TECHNICAL SERVICE BULLETIN

MT88 Manual Transmission - Rotational Scraping Noise When Cold And In Neutral, 1st And/Or 2nd Gear With Clutch Pedal Released

24-2042

This bulletin supersedes 23-2019. Reason for update: add 2024 model year vehicles, add an additional labor operation, and correct the part number called out in the Service Procedure.

Figure 1

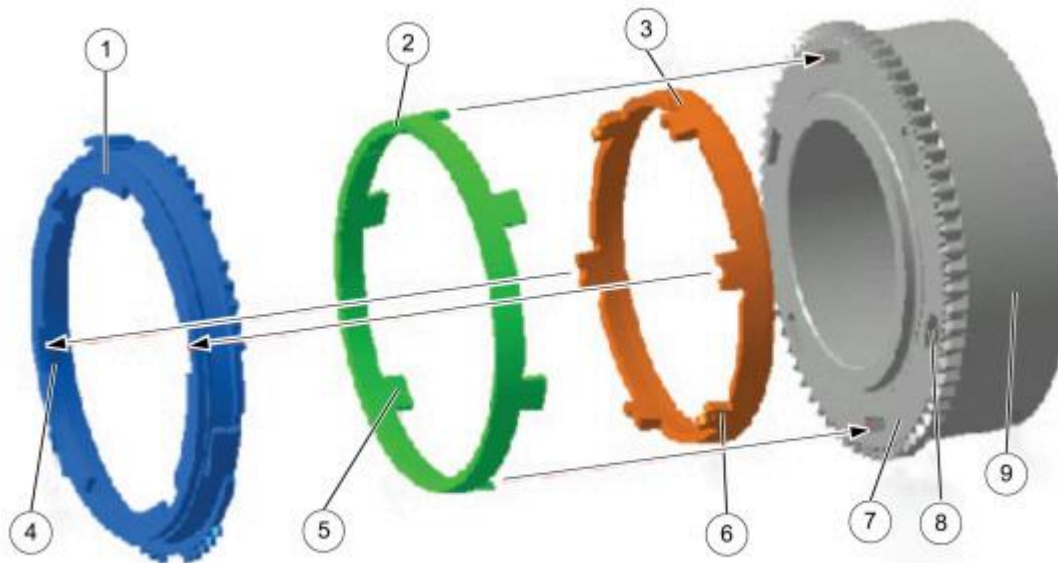
(1). The reverse/crawl gear synchronizer assembly must be assembled on the transmission. Refer to Figures 1-2 for an exploded view of the reverse/crawl gear synchronizer assembly (Figures 1-2).
